737

Service Bulletin

Number: 737-27A1306
Original Issue: September 10, 2015
ATA System: 2741 3151 7611

SUBJECT: FLIGHT CONTROLS - Horizontal Stabilizers - Stabilizer Trim Control System for
737-700 Airplanes with Blended Winglets - Change

FIGURE 1: FLIGHT COMPARTMENT CONTROL STAND - STABILIZER TRIM LIGHTPLATES - REMOVAL (SHEET 1 OF 2)

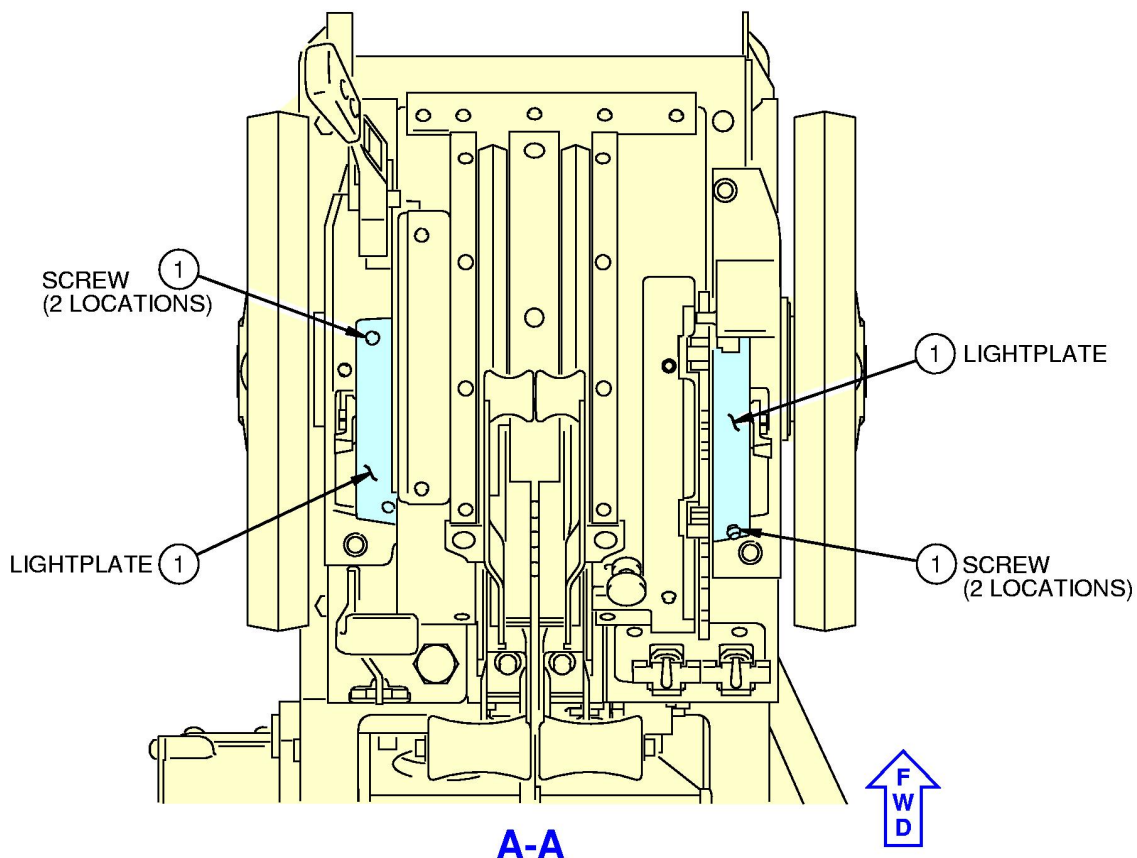
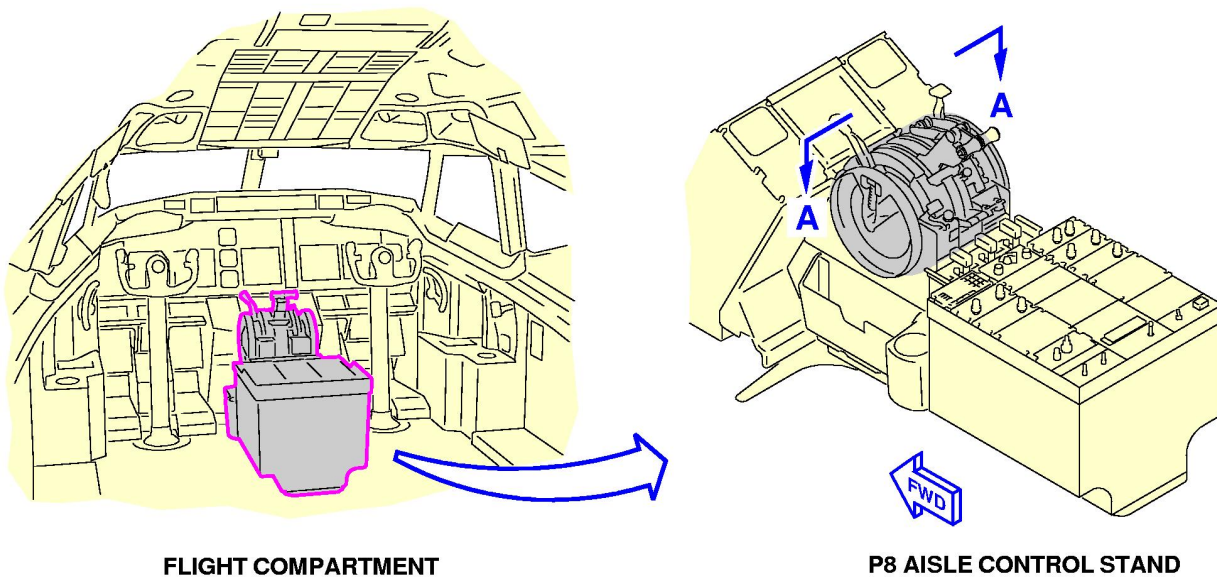
1. RC - Do the change in accordance with the instructions for Group 2 airplanes in Aviation Partners Boeing Service Bulletin AP737-27-002, but do not use steps 7 and 8 of PART 3 to remove the control stand stabilizer trim lightplates. Use FIGURE 1 of this service bulletin to remove the control stand stabilizer trim lightplates.

Step	Task	Name	Identification	Qty	More Data
1	Remove / Keep	SCREW	PS4C9DL01BK	4	(a)
	Remove	LIGHTPLATE	800-010310-1	1	This is on the Captain's (left) side. (a)
	Remove	LIGHTPLATE	800-010311-1	1	This is on the First Officer's (right) side. (a)
(a) Refer to 737-600/700/800/900 AMM 76-11-03 as an accepted procedure.
